February 9, 2018

**Re: Natural Gas Combined Cycle Minor Modification  
Electric Transmission Line and Storm Outfalls Rehabilitation  
NPDES Permit #: PAC060046  
BCCD Project ID #: ESP-00731  
Dawood Project No. 216040.01**

Enclosed, please find revised documents for the above-referenced project updated per comments received from the DEP Chapter 105 permitting review. These documents have been revised to adjust the location of construction fence and supply additional information regarding the areas with equipment and grubbing restrictions. In addition, work associated with outfall 1 has been removed from the project as it is not required and additional notes concerning construction monitoring and waste management have been added.

A1

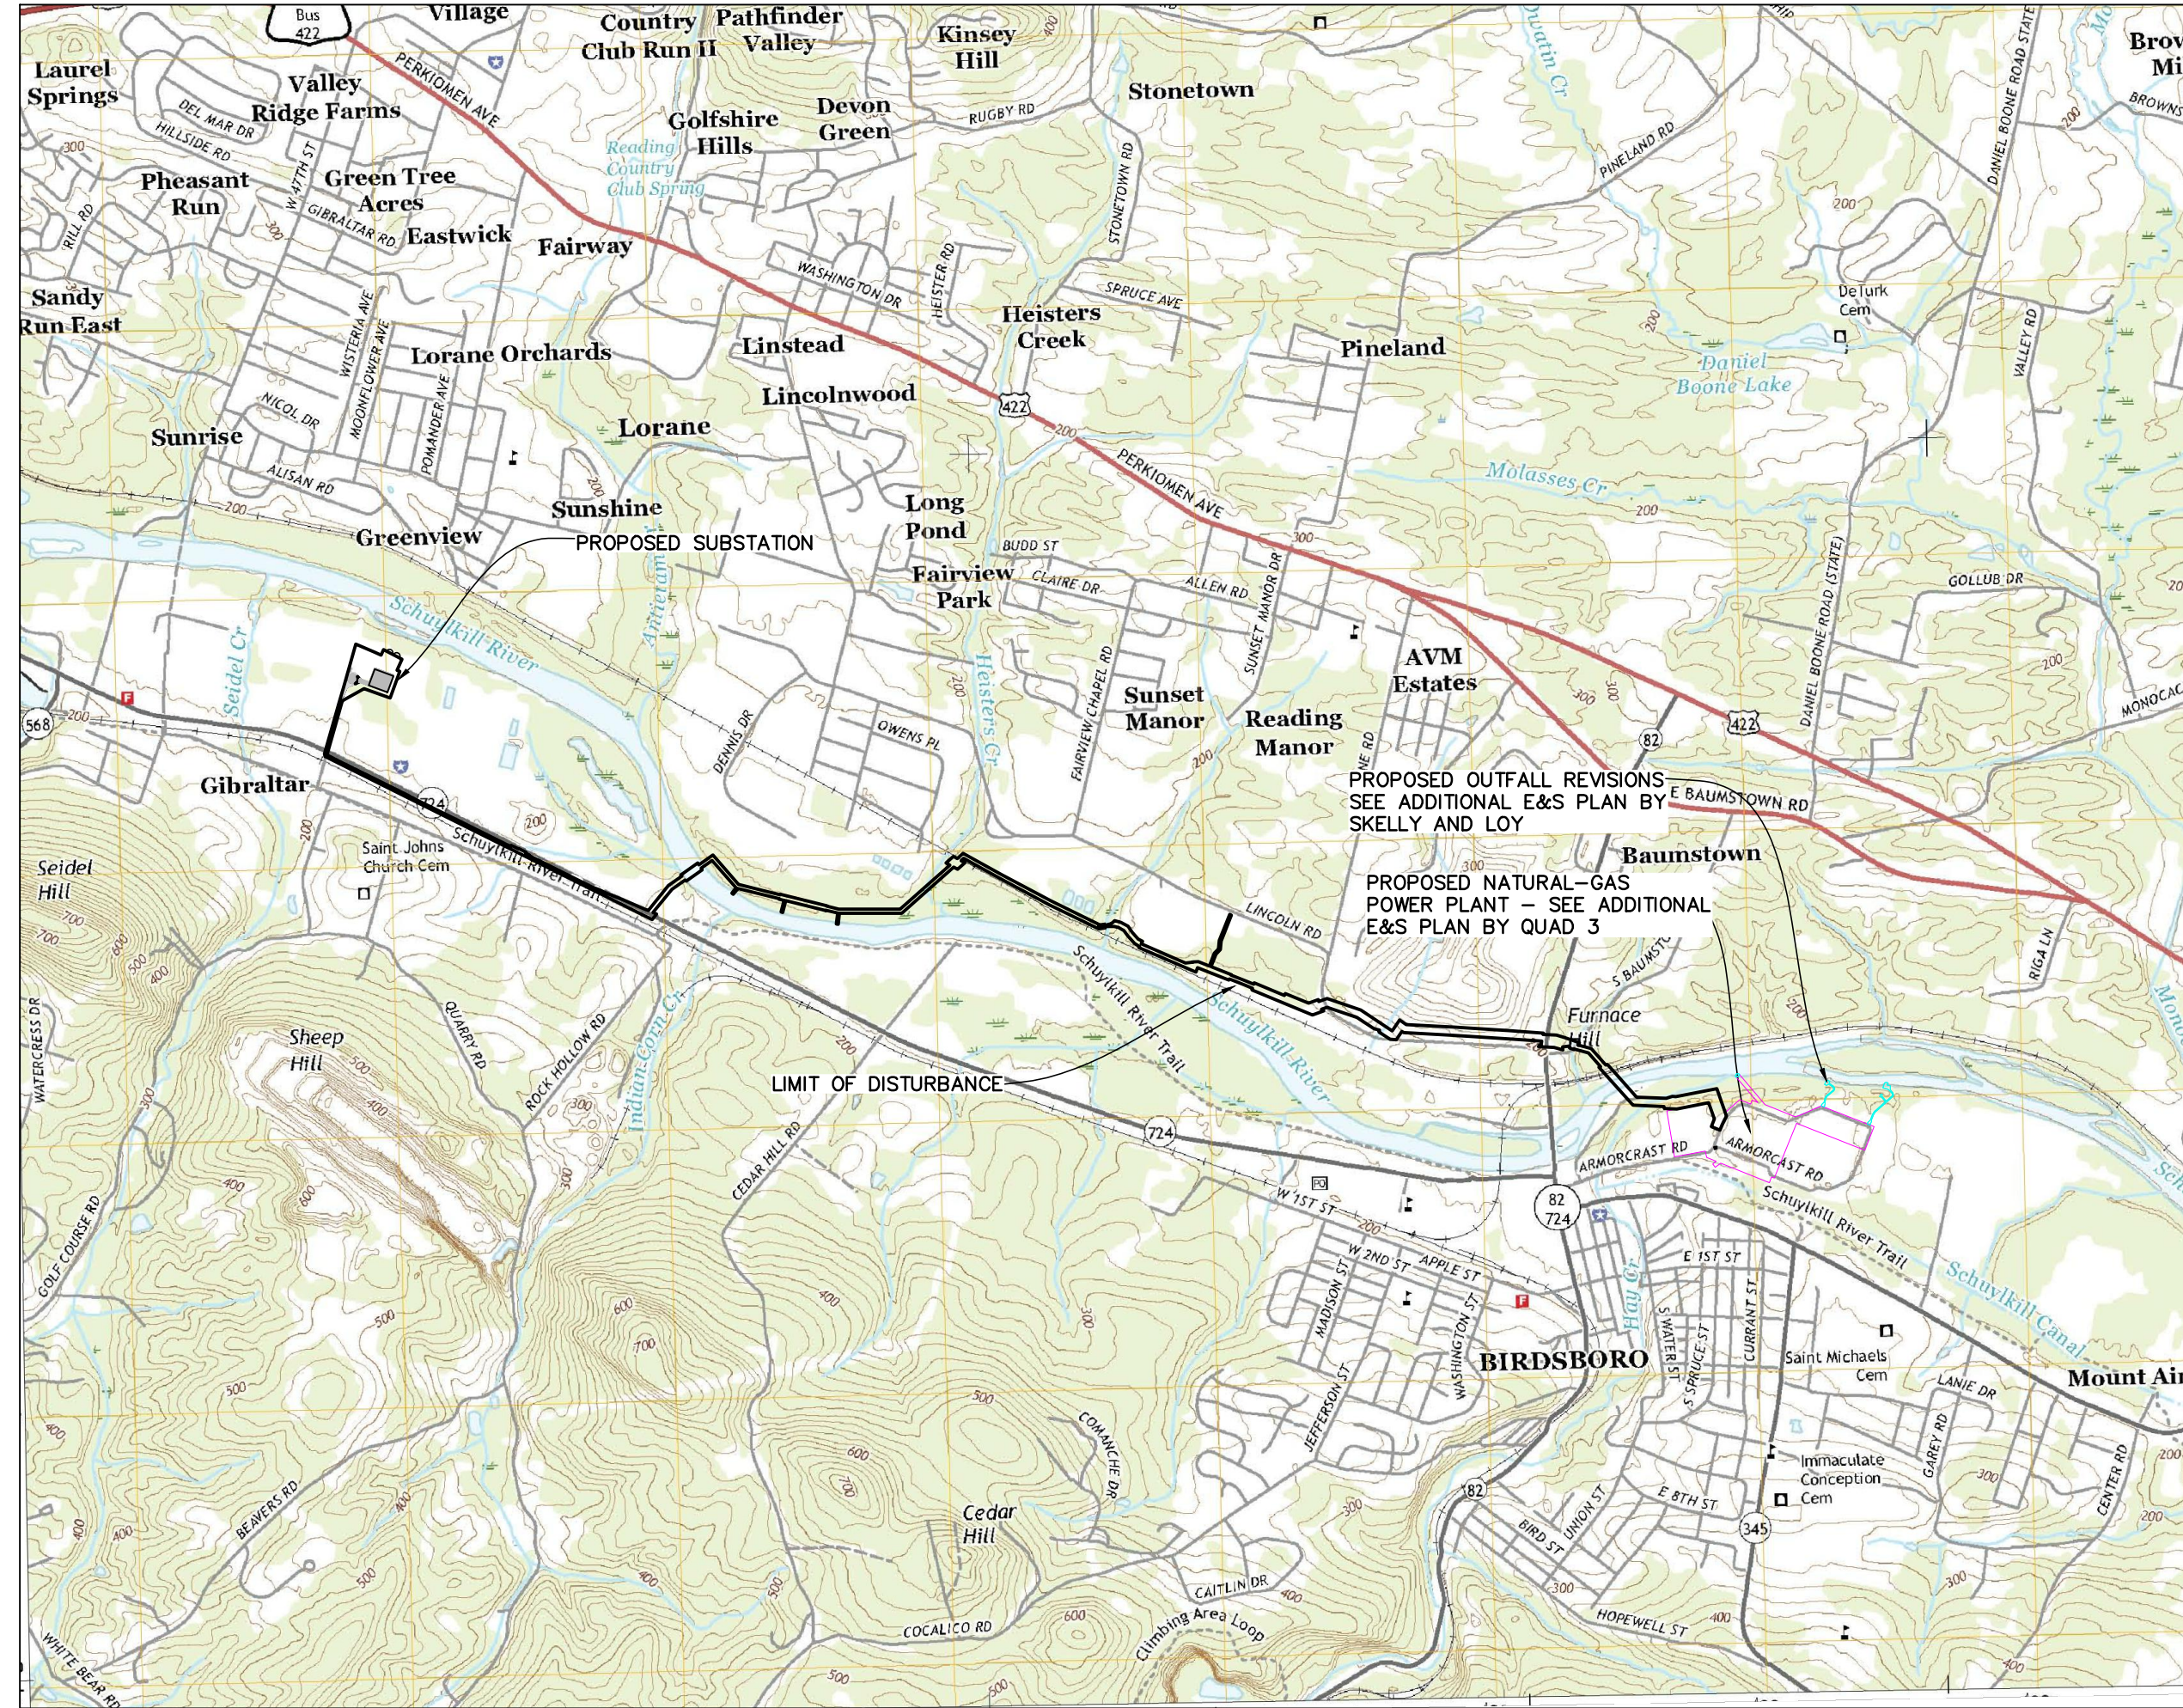
1. ESCP A1 (Page 398)– Sequence of BMP Installation has been updated to specify hand clearing areas per DEP Chapter 105 review comments. Outfall 1 has been removed from location map.

B100

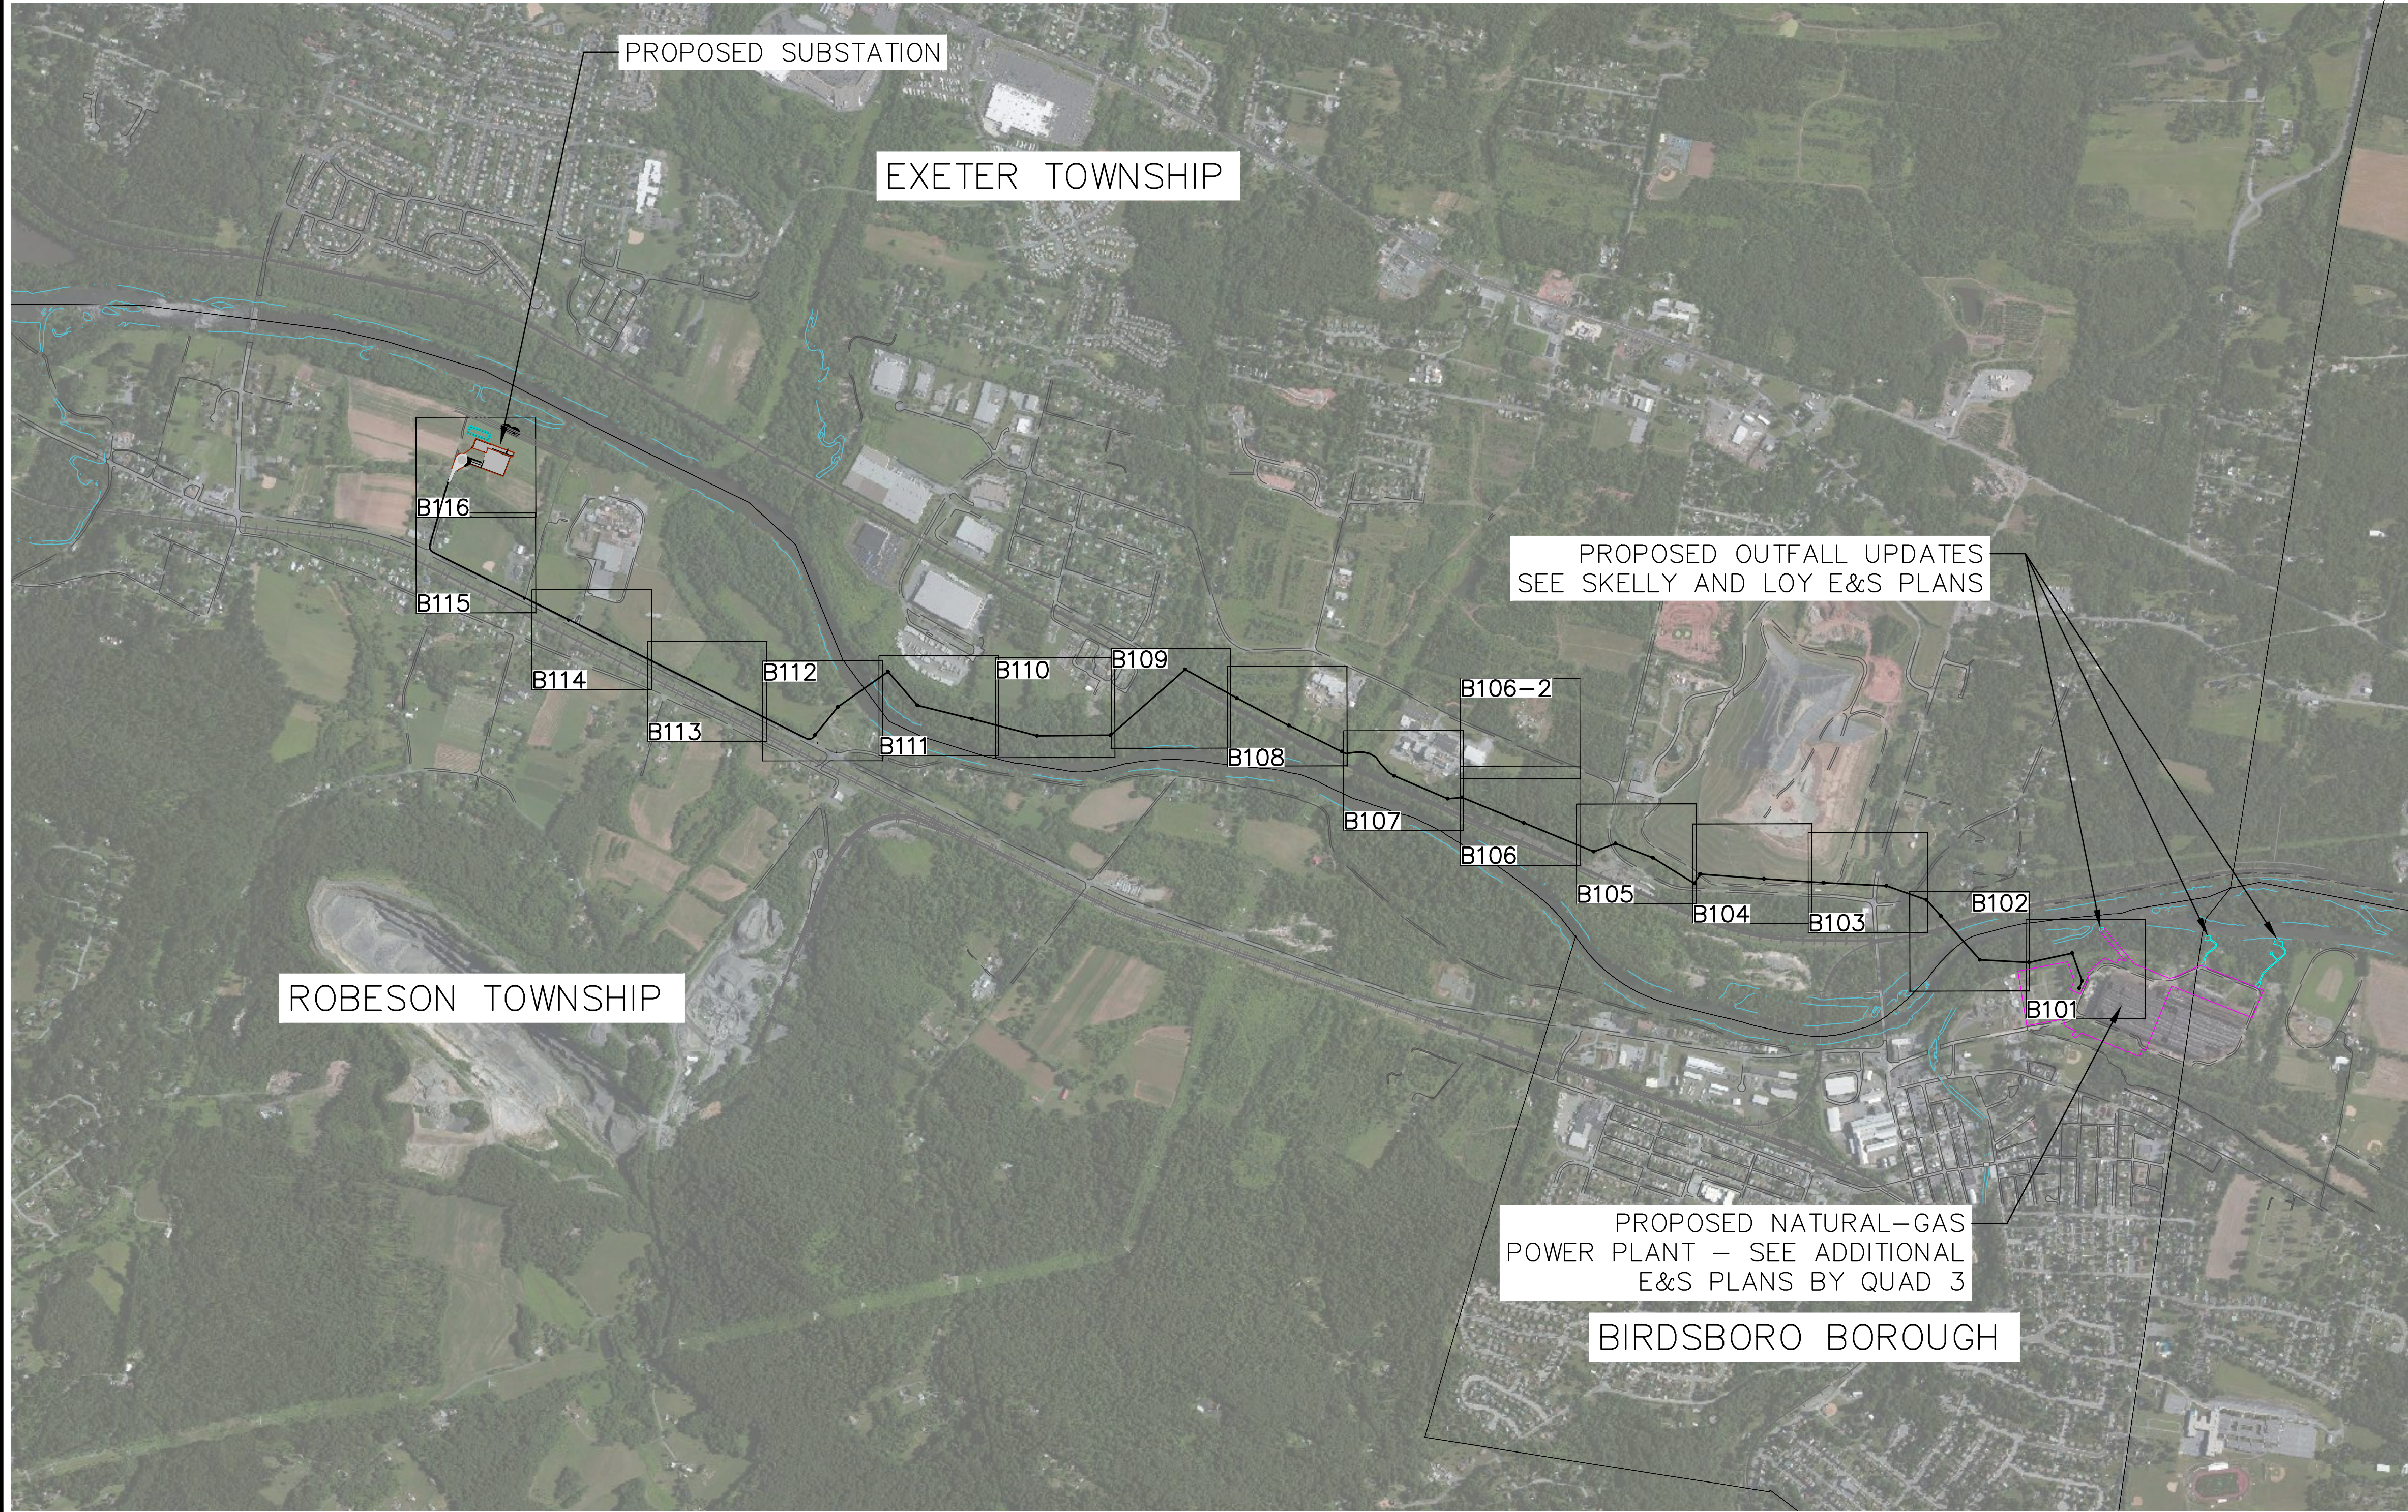
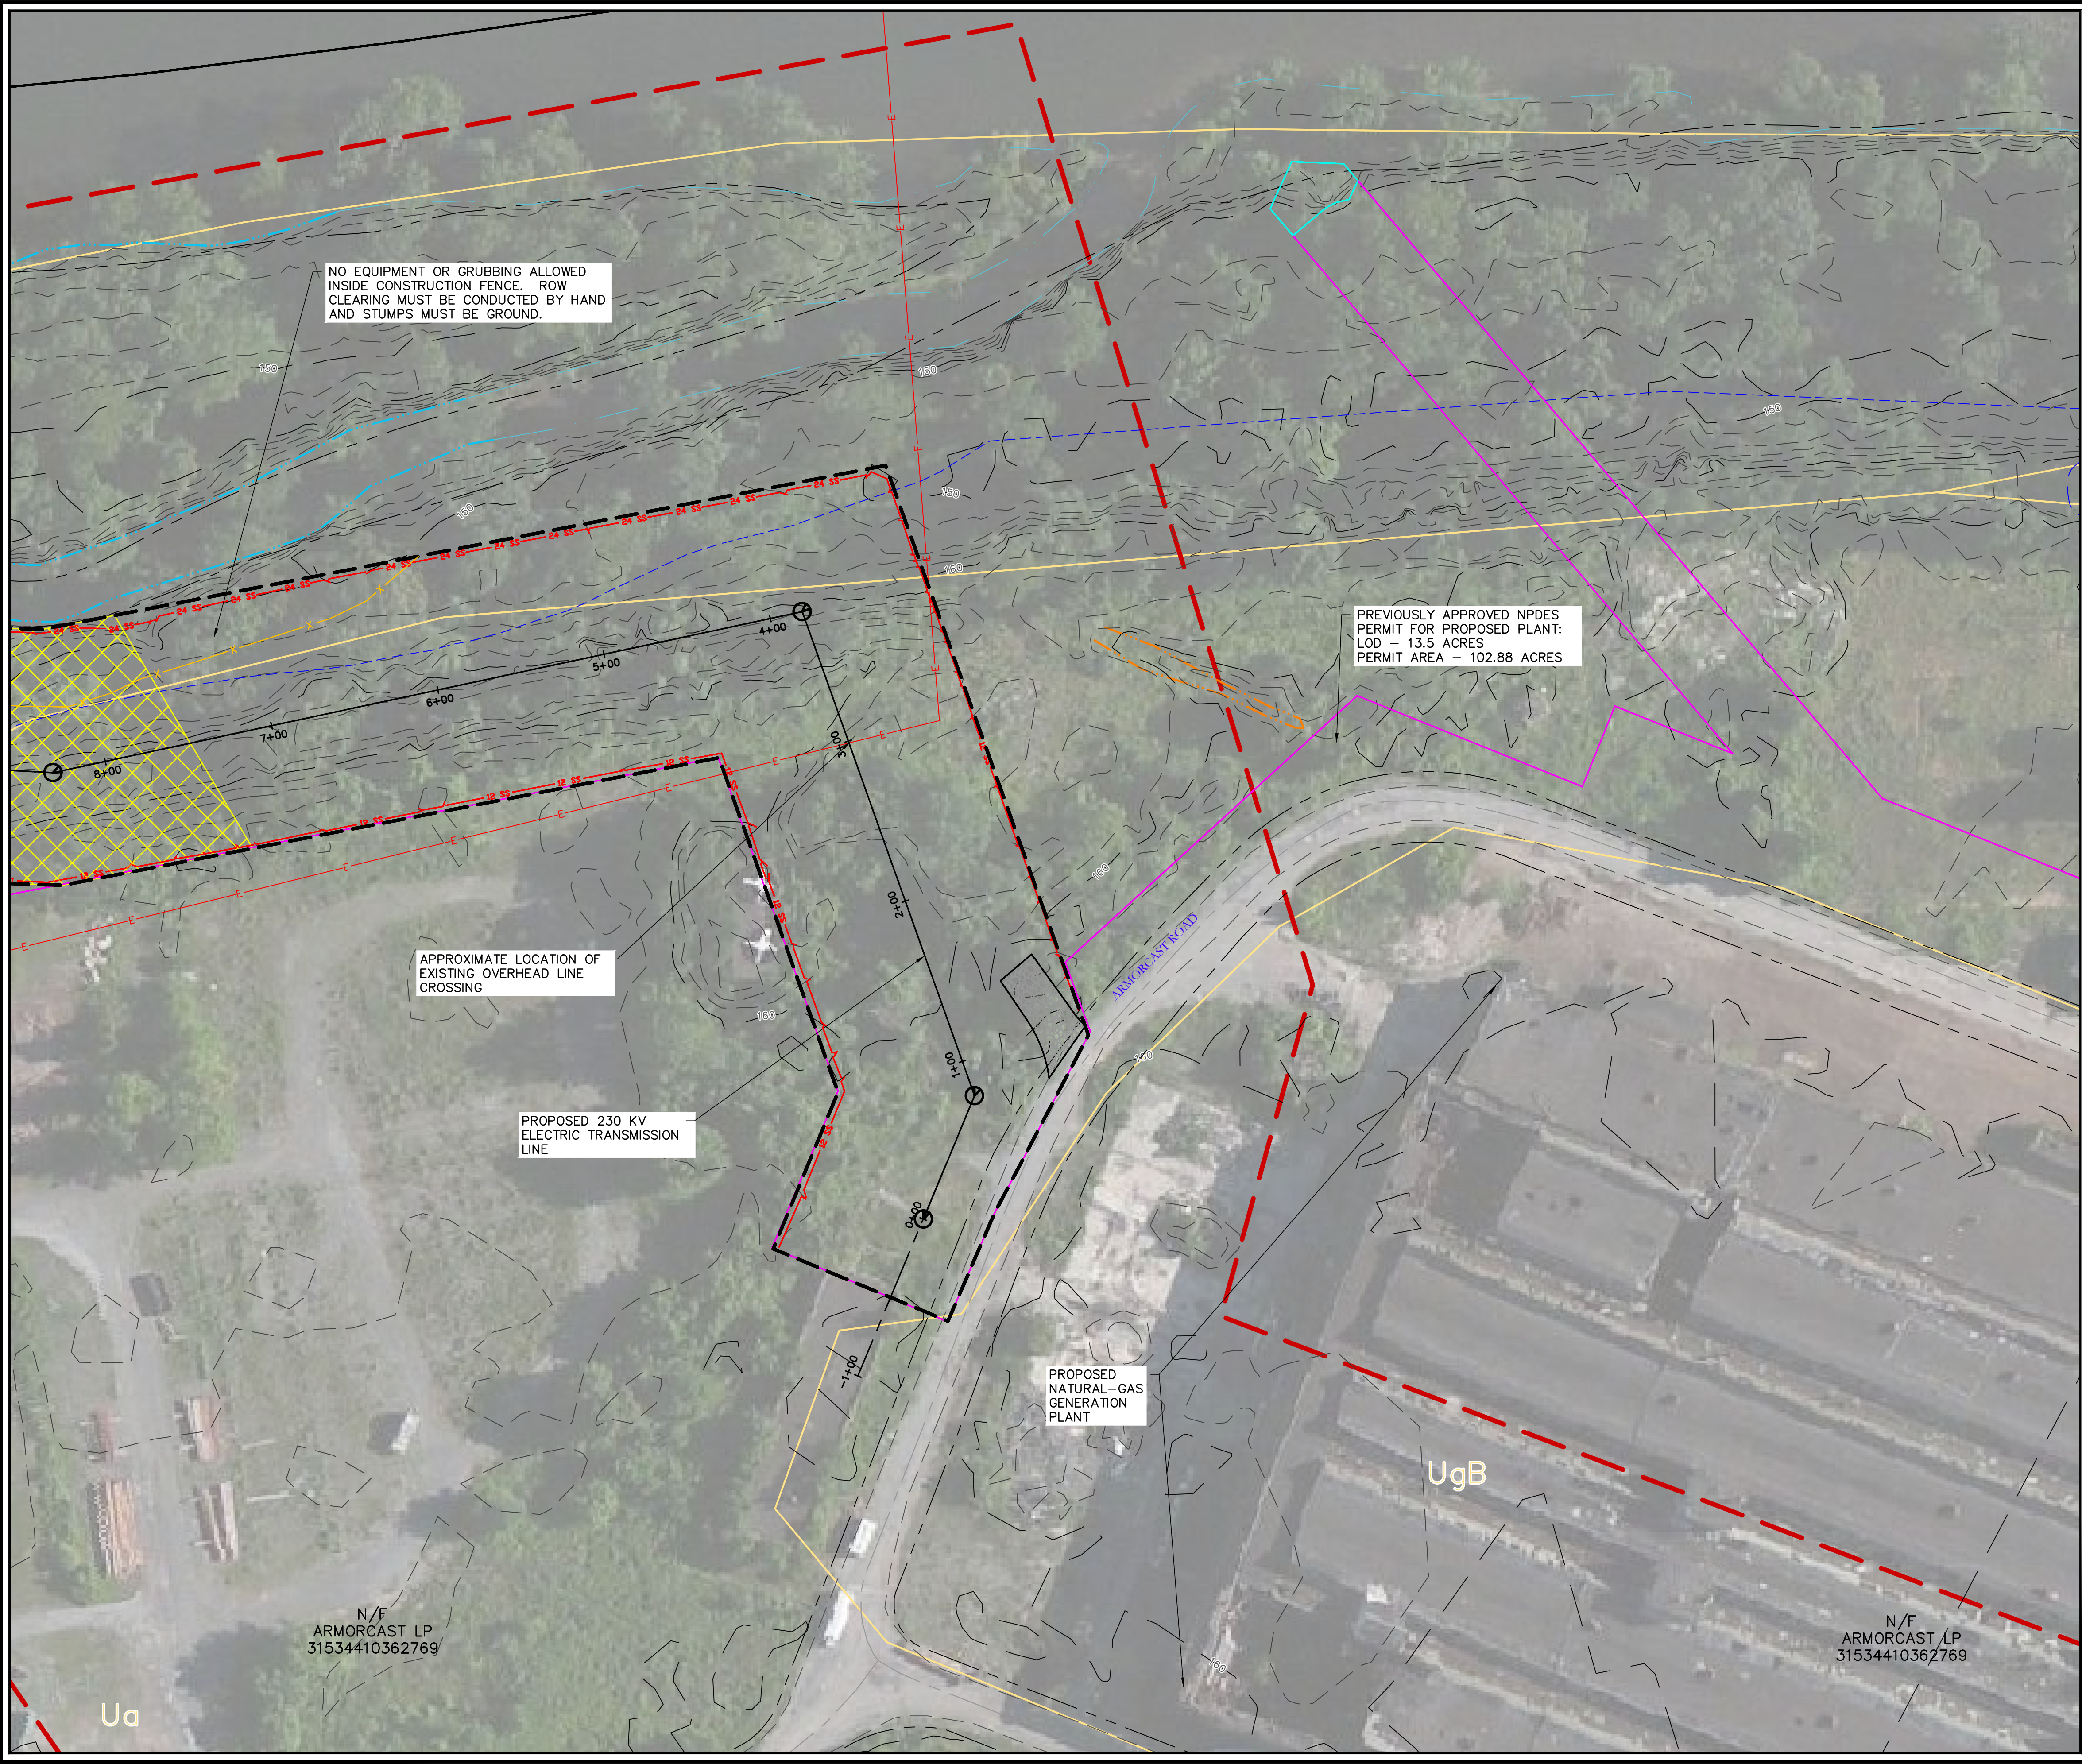
2. ESCP B100 (Page 399)– Key has been added for annotations concerning construction fence locations. Outfall 1 has been removed from the map.
3. ESCP B101 (Page 400)– Additional area has been added where no equipment or grubbing is allowed. Outfall 1 work area has been removed. No change in silt sock or limit of disturbance.
